SUBJECT: Second Ten Year Inservice Inspection Program

Byron Nuclear Power Station, Units 1 and 2
Facility Operating Licenses NPF-37 and NPF-66
NRC Docket Nos. 50-454 and 50-455

ATTACHMENT 1
RAI QUESTIONS AND RESPONSES

ATTACHMENT 3
REVISED RELIEF REQUESTS

Figure 1

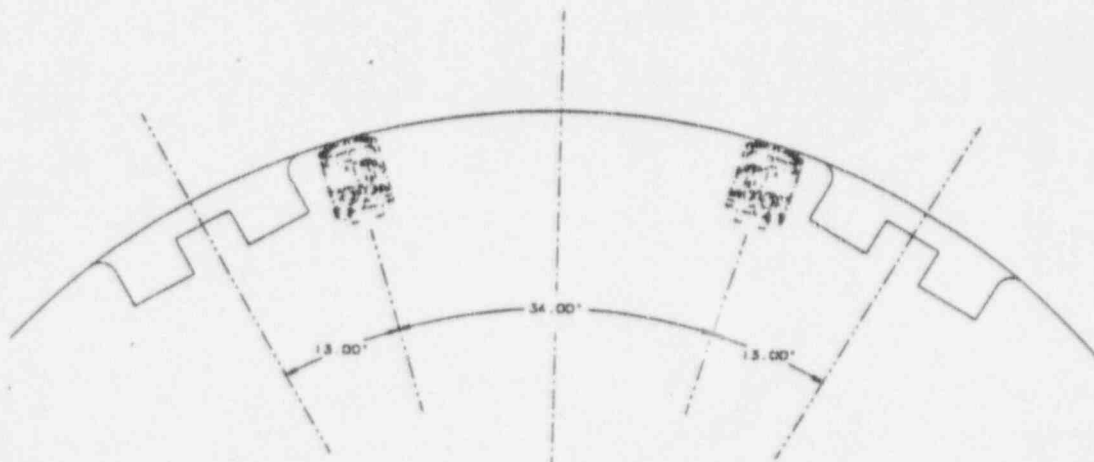
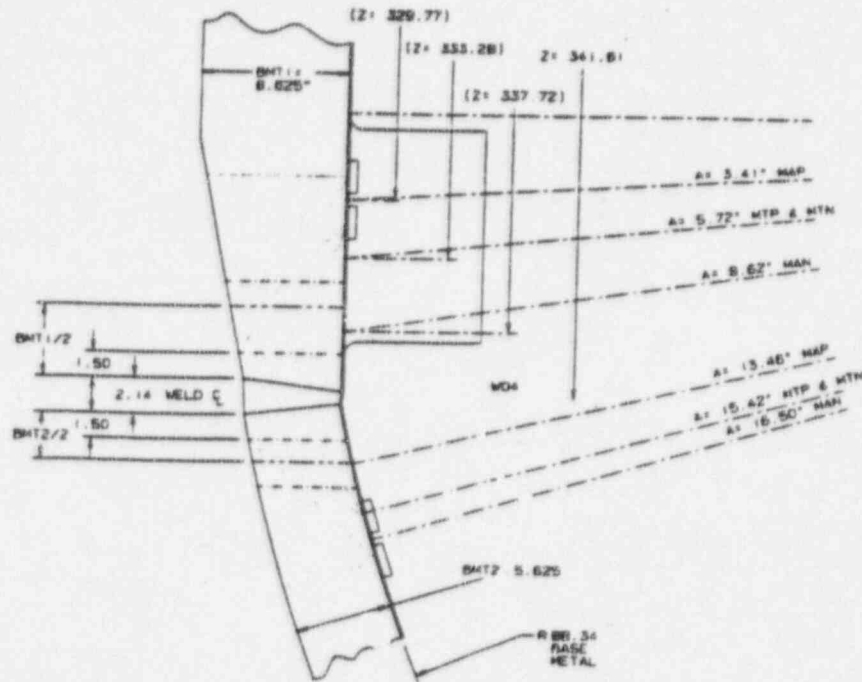
The examination of the Unit 1 Lower Shell Course-to-Dutchman weld, RPVC-WR29, is restricted by six (6) core barrel locating lugs welded to the inner surface of the vessel approximately 4 inches above the weld (See Figure 1). These lugs obstruct the automated UT inspection tool from examining the code required volume of the weld below each lug (156°). The FTI "URSULA" tool has a 6 degree movement arm and the physical size of the lugs and the "yaw" joint of the tool prevented scanning below the lugs back into the weld and surrounding base metal. All weld metal can be examined from both sides where access is available between the lugs (204°). Examinations for perpendicular and parallel reflectors covered areas accounting for 57% of the weld metal and heat affected zone (HAZ). Similarly, 57% of the weld metal can be examined for transverse reflectors from two opposing directions.

The examination of the Unit 2 Lower Shell Course-to-Dutchman weld, RPVC-WR29, is similarly obstructed (see Figure 1). All weld metal can be examined from both sides where access is available between the lugs (204°). Examinations for perpendicular and parallel reflectors can cover areas accounting for 57% of the weld metal and heat affected zone (HAZ). Similarly, 57% of the weld metal can be examined for transverse reflectors from two opposing directions.

Figure 2

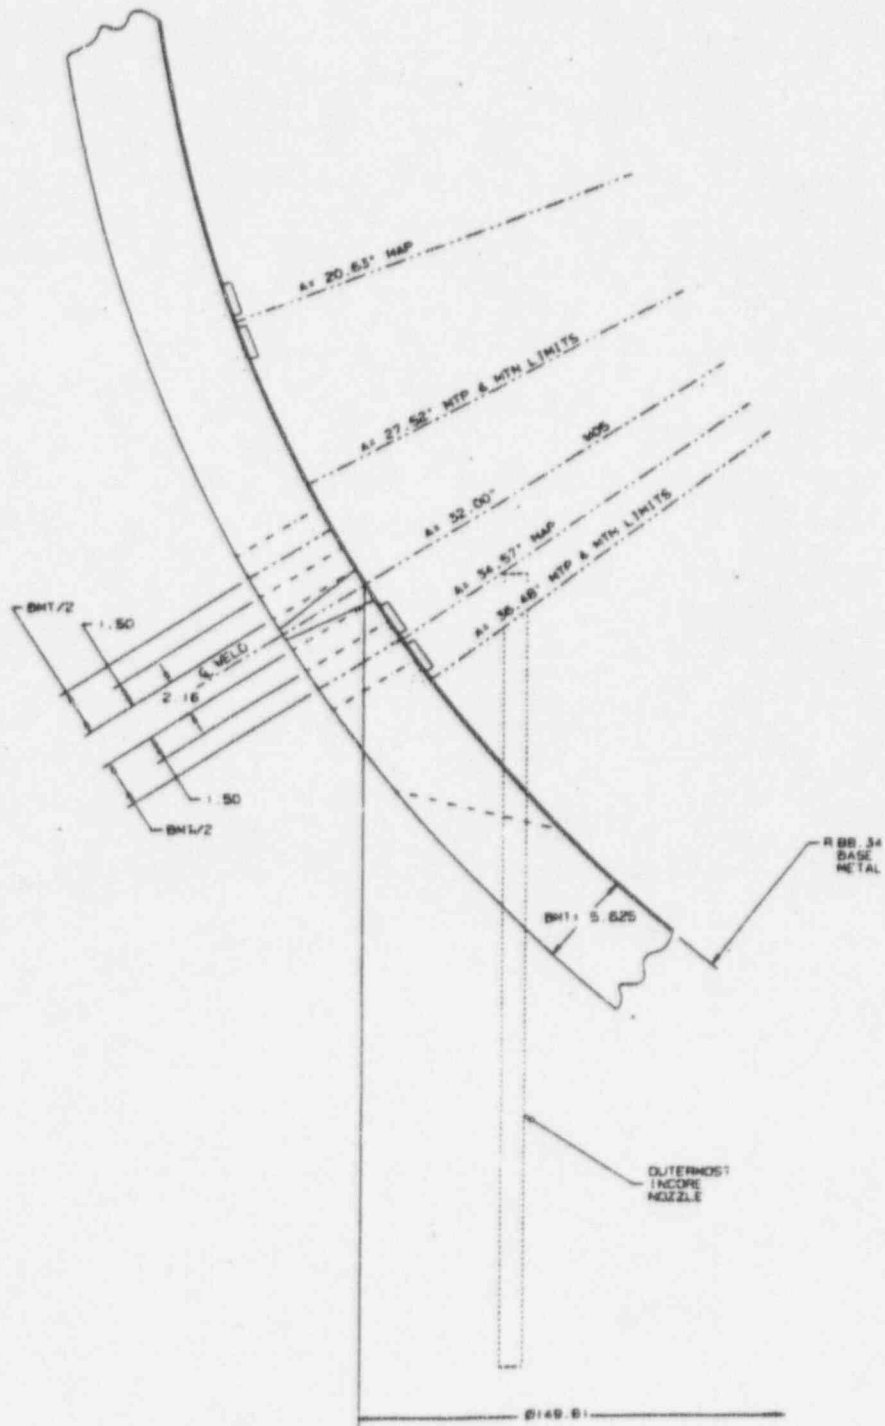
The examination of the Unit 1 Lower Disk-to-Dutchman weld, RPVC-WR16, is restricted by the 58 instrument tubes that penetrate the lower disk and physically obstruct the UT search unit and/or the search unit position device as shown in Figure 2 and 3. Approximately 19% of the weld length cannot be examined. The weld and the HAZ received essentially 100% coverage for parallel reflectors from the Dutchman side and for transverse reflectors in two opposing directions. Partial coverage is achieved for parallel reflectors from the disk side on the remainder of the weld resulting in an aggregate of all scan coverage of approximately 81%.

The examination of the Unit 2 Lower Disk-to-Dutchman weld, RPVC-WR16, is similarly restricted, see Figure 2 and 3. The weld and the HAZ will receive essentially 100% coverage for parallel reflectors from the Dutchman side and for transverse reflectors in two opposing directions. Partial coverage can be achieved for parallel reflectors from the disk side on the remainder of the weld resulting in an aggregate of all scan coverage of approximately 81%.
